N&W GLOBAL VENDING

TYPE NO	TYPE	T.I.-NO
XX2800	All types	2800-2005-01

SERIAL NUMBERS AFFECTED: Before and including machine number 560343	ISSUED BY: Documentation/ Wittenborg Odense
SUBJECT: Adjustment of actuator on drip tray	ISSUED FOR (X): Action / Information: x

Ill. 1

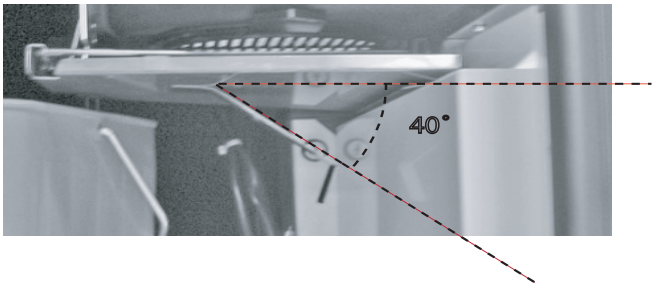
- The angle of the bend is changed from 20° into 40°.

- The actuator on the drip tray in machines before machine number 560344 needs to be adapted to the new waste bucket - part no 39722800 - as follows:

1. Open the door and place the waste bucket in its brace (ill. 1).

2. Bend the actuator until the angle is approx. 40° (ill. 2).

Tip!
- remove drip tray and grid,
- reinsert drip tray without grid,
- close the door,
- and observe the drip tray through the hole for grid.

If the drip tray is sloping towards the waste bucket, the angle of the actuator is correctly adjusted. Reinsert grid again.
